CLINCH RIVER  
BREEDER REACTOR PROJECT

**PRELIMINARY  
SAFETY ANALYSIS  
REPORT**

PROJECT MANAGEMENT CORPORATION

FIGURE QCS 421.4-2

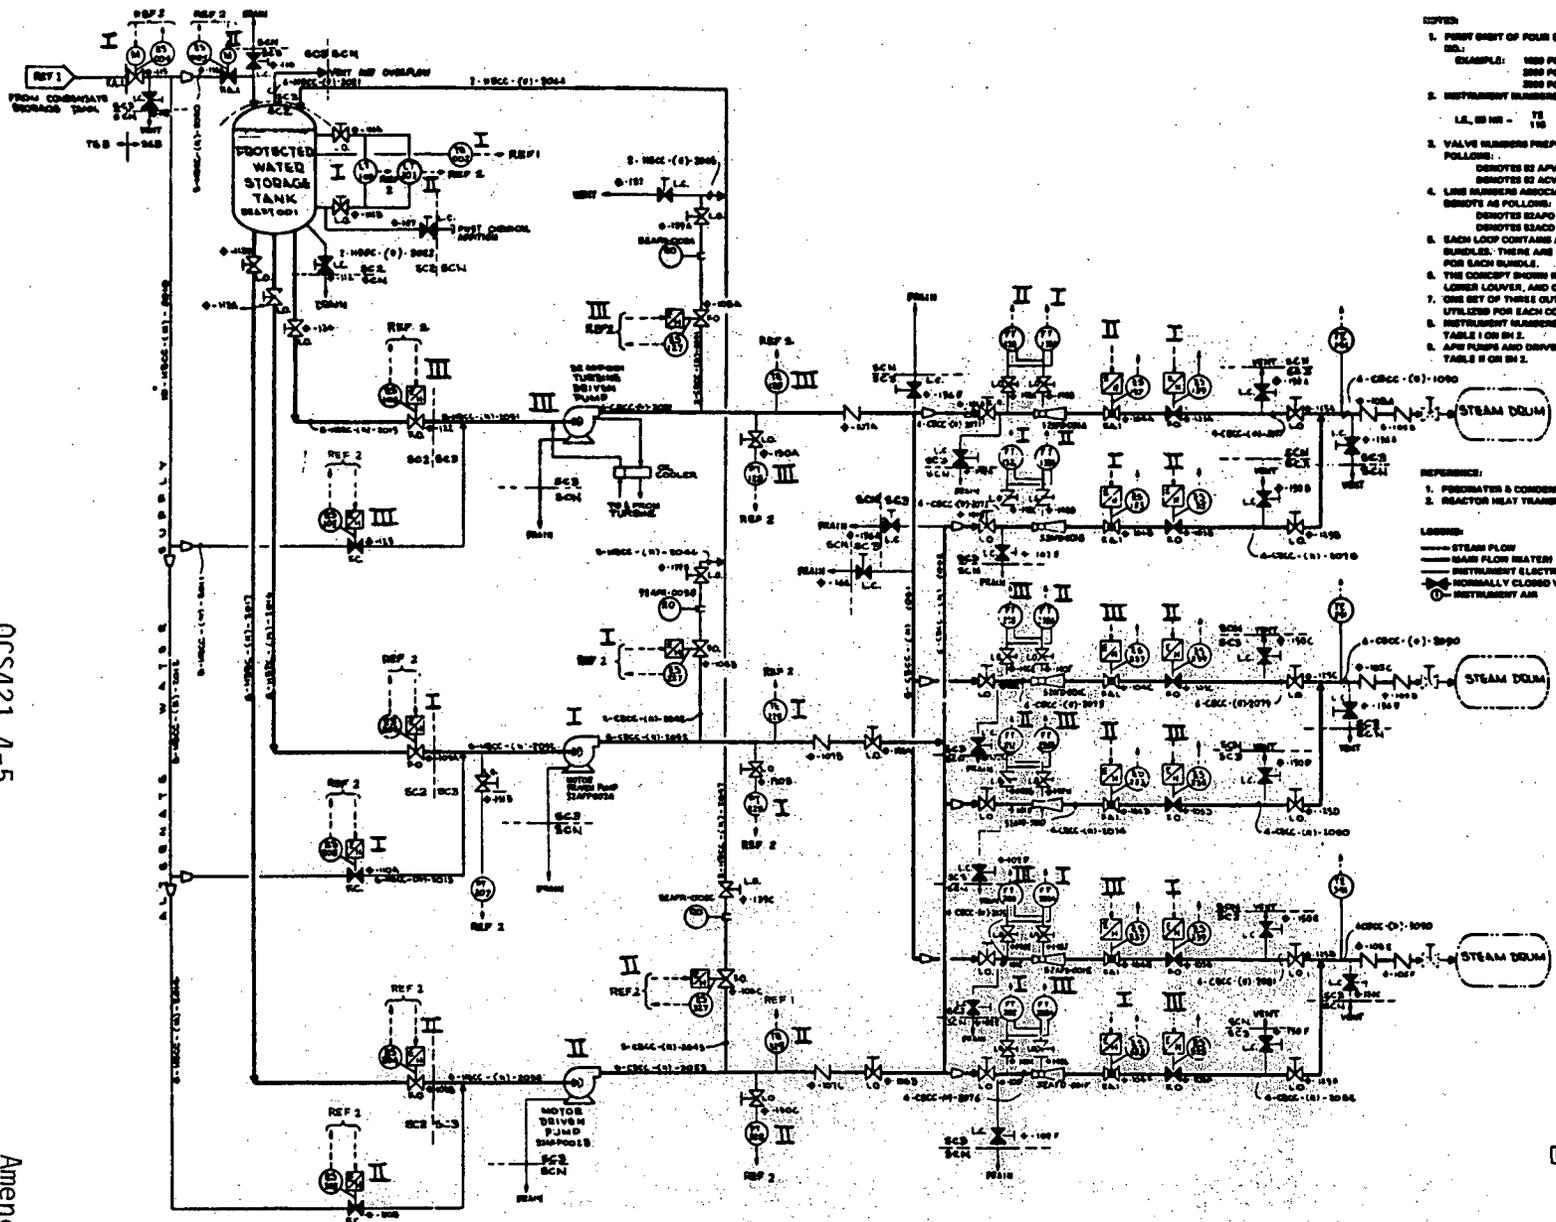
Figures 5.1-5 and 5.1-5a of the PSAR (attached) have been marked up (Figure QCS421.4-1, 2) to show the power division assignments for all valves and safety grade instrumentation. The controls for the devices are not shown, however, the power assignment is the same as that of the valves, louvers, and fan blade pitch control being actuated. The normal position and failure position of the valves are shown in Figures 5.1-5 and 5.1-5a.

As shown in Figure 5.1-5 there are six isolation valves, two in parallel to each steam drum. One valve supplies water from the electric driven pumps, the other, from the turbine drive pump. Each capable of supplying 100 percent water flow to the steam drum. These two valves are supplied power from separate Class 1E power divisions. The failure of one valve to open on demand would not result in the loss of water to a steam drum, as the required water would be supplied by the parallel line.

In addition, Figure 5.1-5 shows that there are flow control valves in series with these isolation valves. Each of the flow control valves is supplied with power from a Class 1E power division different from the Class 1E power division supplied to the isolation valve in the same line.

Figure QCS490.8-1

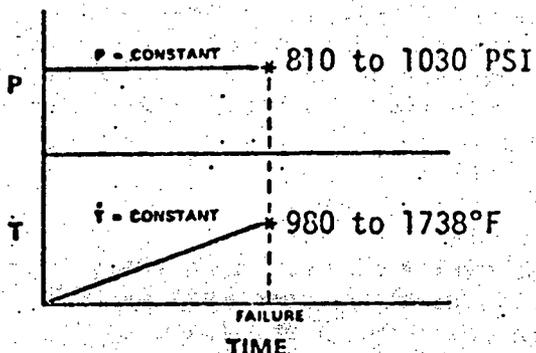
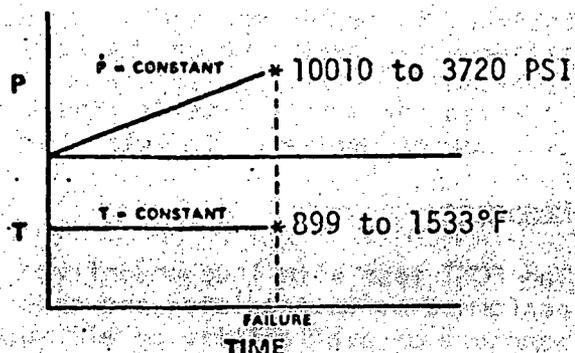
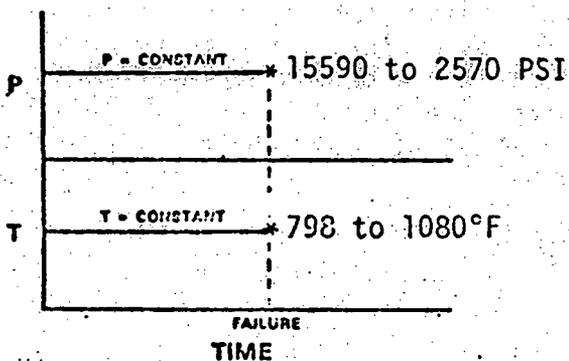
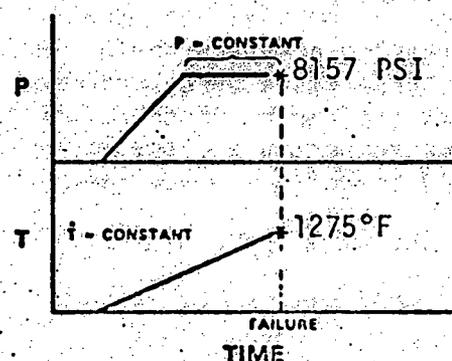
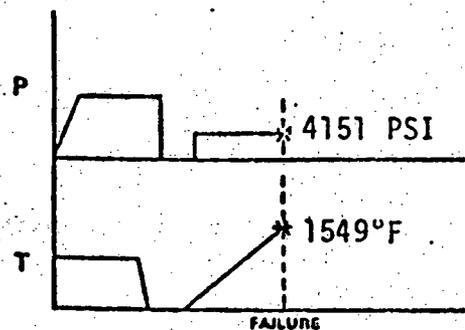
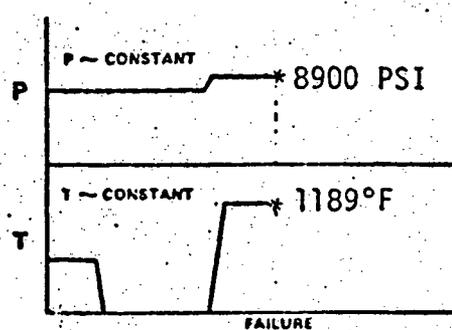
In addition, FCTT type tests with unirradiated and defueled cladding were performed at HEDL, not at controlled strain rates, but at constant temperature and increasing pressure and at variable ratios of pressure and temperature ramps. These tests were performed to simulate the pressure-temperature histories similar to those referenced in the questions. Figure QCS490.8-1 shows the temperatures, pressure-time histories of these tests, the number of tests and cladding fluence ranges.

Figure QCS490.11-1. Cumulative Mechanical Damage Due to Steady State Operation at X/L = 1.0

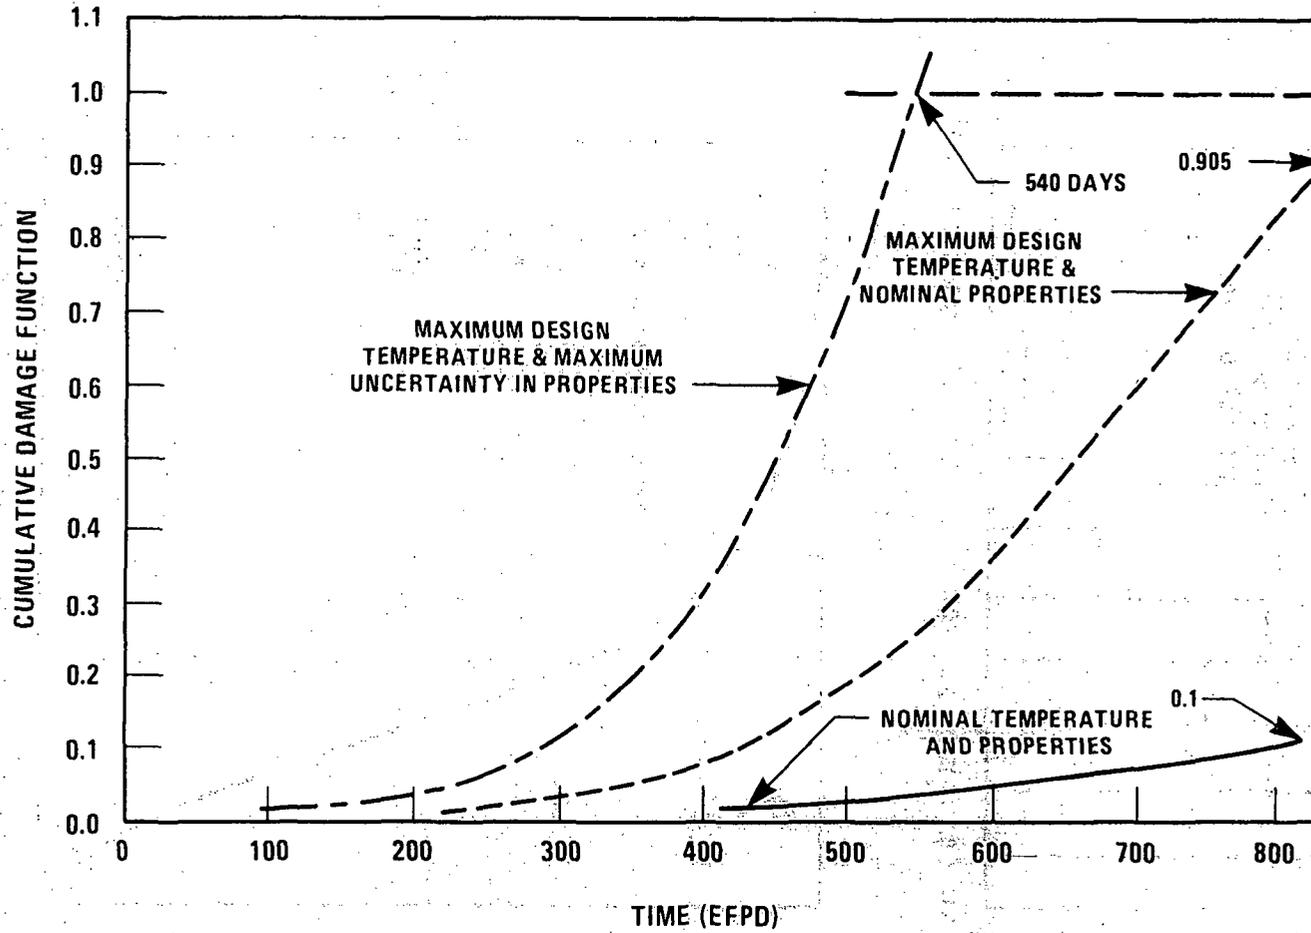
The results of the typical deterministic design level analysis for the subject pin is given in Figure QCS490.11-1. As shown, by combining all properties at their worst confidence levels a CDF = 1.0 is achieved after 540 EFPD. In comparison, a combination of properties at their nominal levels (with the 2 factors still prevailing) yields a CDF of 0.905 after 825 EFPD.

Figure QCS490.11-2. Distribution of Possible CDF Values at  $X_L = 1.0$  After 540 EFPD of Steady State Operation

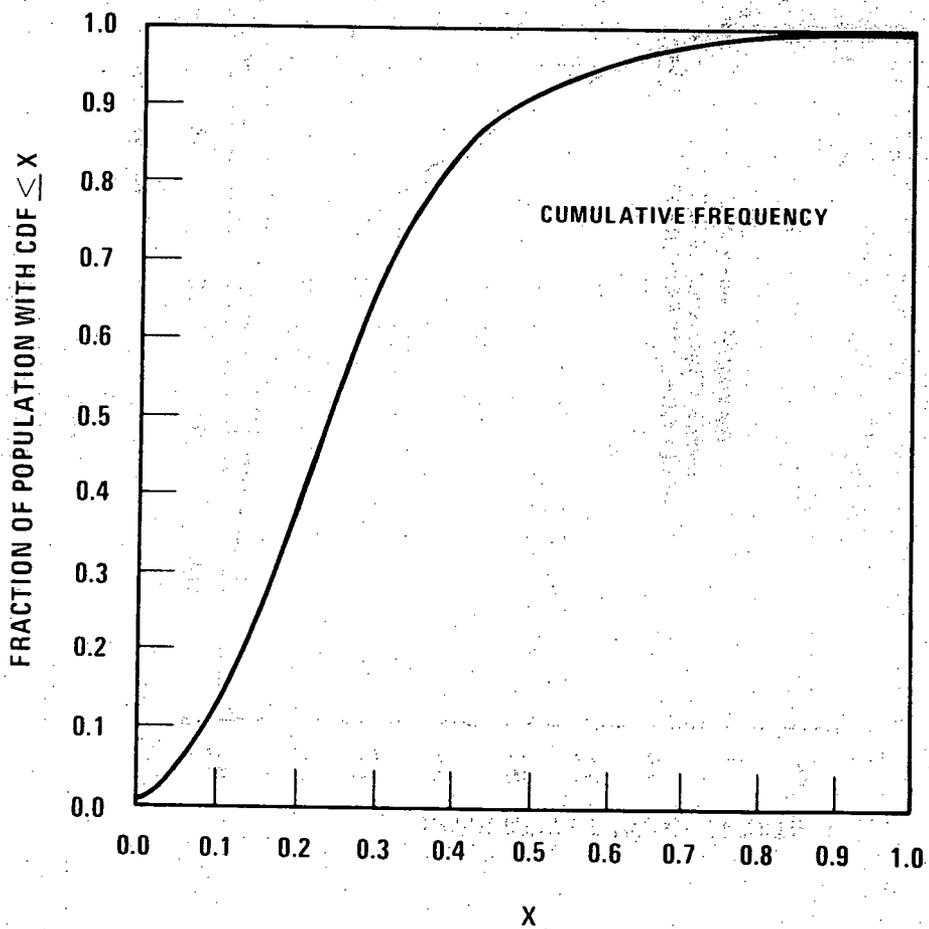
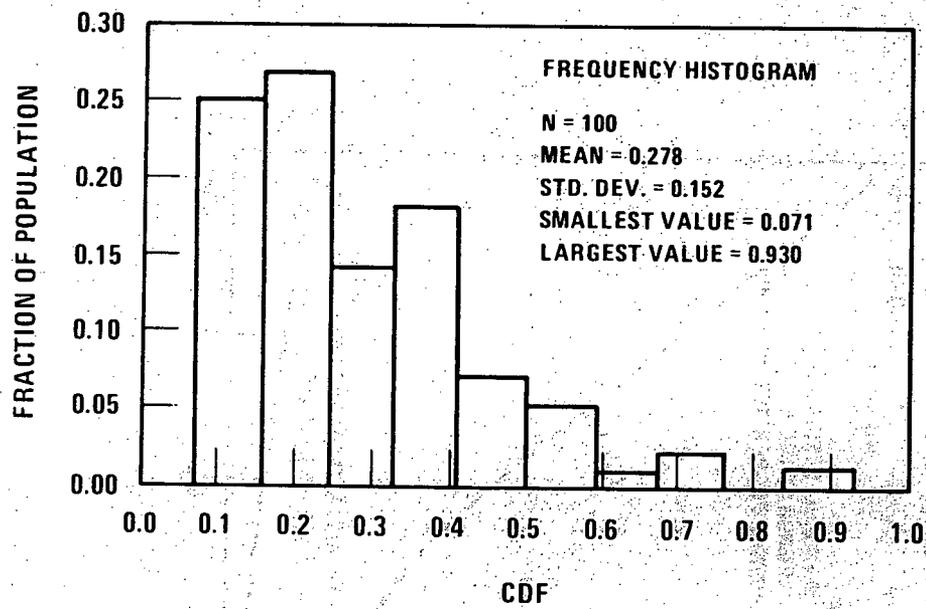
The Monte Carlo analysis involved 100 trials each using a set of properties which were randomly chosen from their respective distributions and randomly combined. Figure QCS490.11-2 gives the resultant distributions of CDF values at 540 EFPD, the time the design limit is achieved. Note that at this time, the entire population of possible CDF values is below unity with 99% of the values less than 0.8.

Figure QCS490.11-3. Cumulative Frequency Distributions in Possible CDF Values at X/L = 1.0 After Various Periods of Steady State Operation

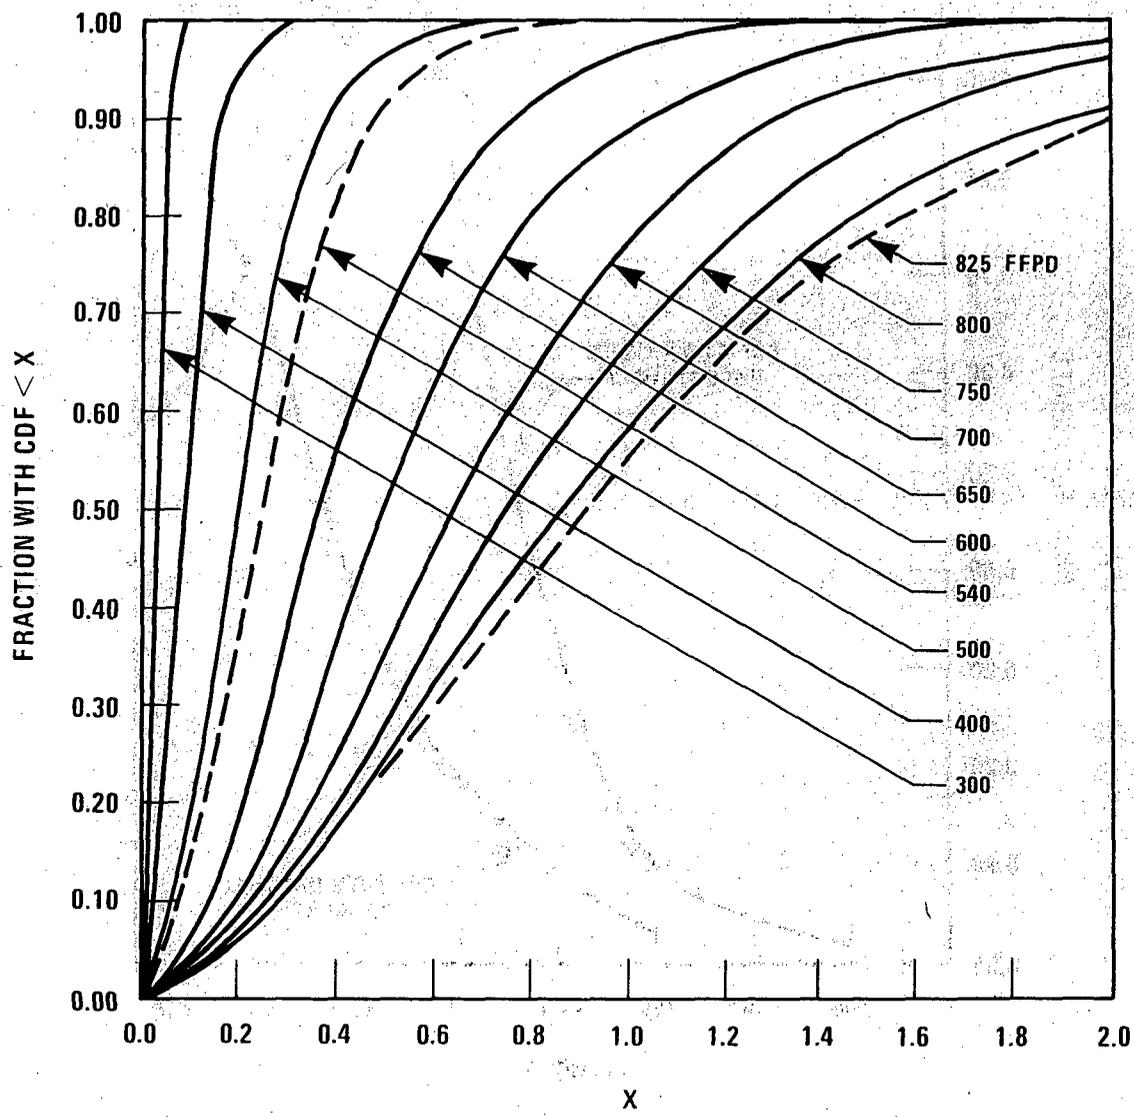
Figure QCS490.11-3 shows the cumulative distributions in the CDF's at various times during the 825 EFPD operating period. As such, this figure represents

Figure QCS490.11-4. Comparison of the Conditional Probability that  $CDF \leq 1.0$  and the Corresponding CDF Values at the Design and Nominal Levels

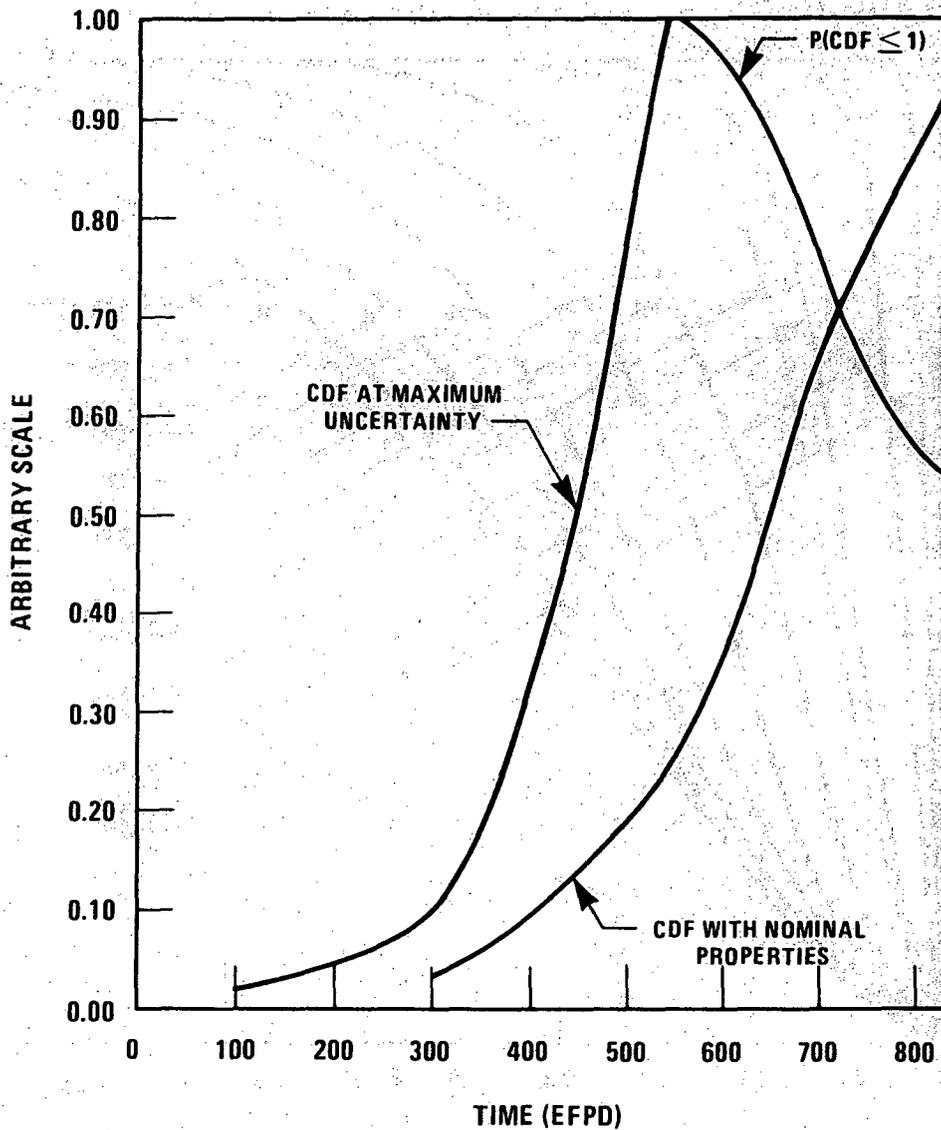
Figure QCS490.11-4 compares the cumulative conditional probability estimate for  $\text{CDF} \leq 1.0$  to the design level and nominal CDF's. As shown, at the 540 EFPD limit  $P(\text{CDF} \leq 1) \sim 100\%$ . At 825 EFPD, where the nominal CDF is 0.91,  $P(\text{CDF} \leq 1) \sim 54\%$ . In other words, at the steady state limit (i.e., 540 EFPD) there is almost a 100% probability that the CDF is less than unity; also, after 825 EFPD there is  $\sim 54\%$  probability that  $\text{CDF} \leq 1.0$ .

Figure QCS490.24-1

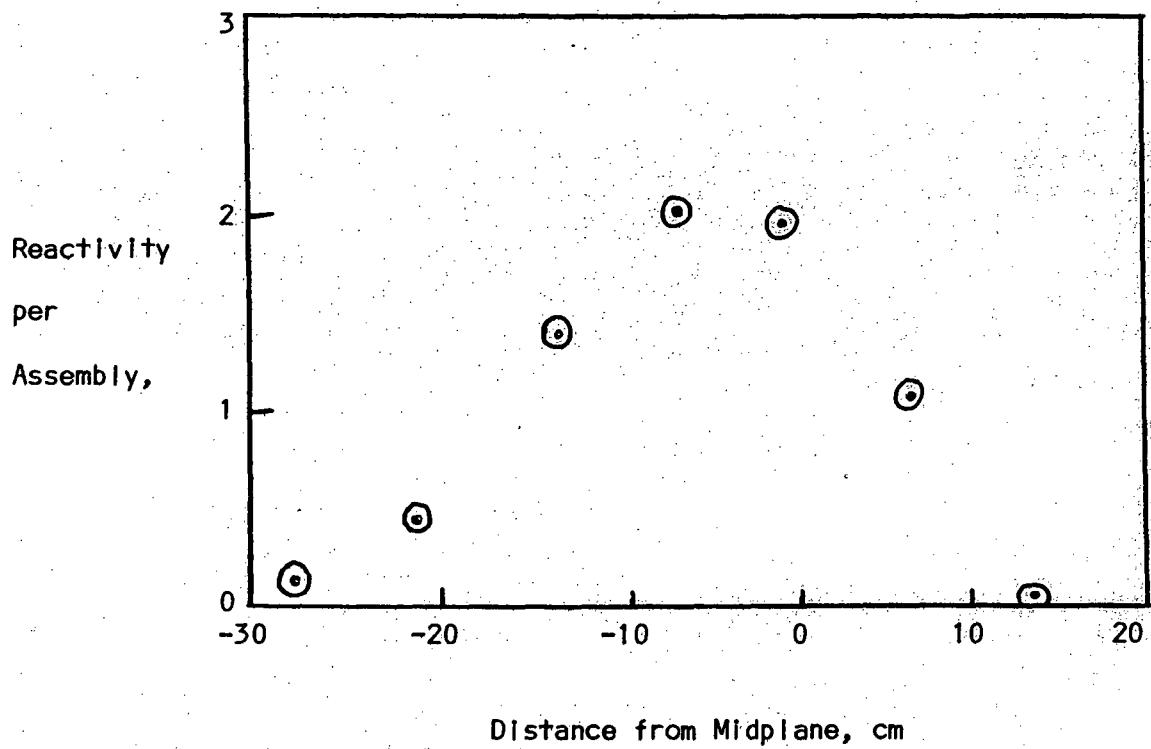
The NRC question speculated that the site of fuel expulsion in the W-2 test may have been influenced by the early cladding breach which was not predicted by current analytical models. This implies that the fuel expulsion site may not be determined accurately within the current models. To address the implication, PLUTO2 calculations have been performed to confirm that the midplane fuel expulsion, which has been analyzed as mentioned above, is the most energetic case. The results of these PLUTO2 calculations are plotted in Figure QCS490.24-1. Examination of Figure QCS490.24-1 shows that the midplane fuel expulsion yields essentially the highest peak positive reactivity feedback from fuel motion. Therefore, it can be said that an early cladding breach may cause at worst fuel expulsion at the midplane, which has been analyzed from the standpoint of the whole core response (Reference QCS490.24-1).
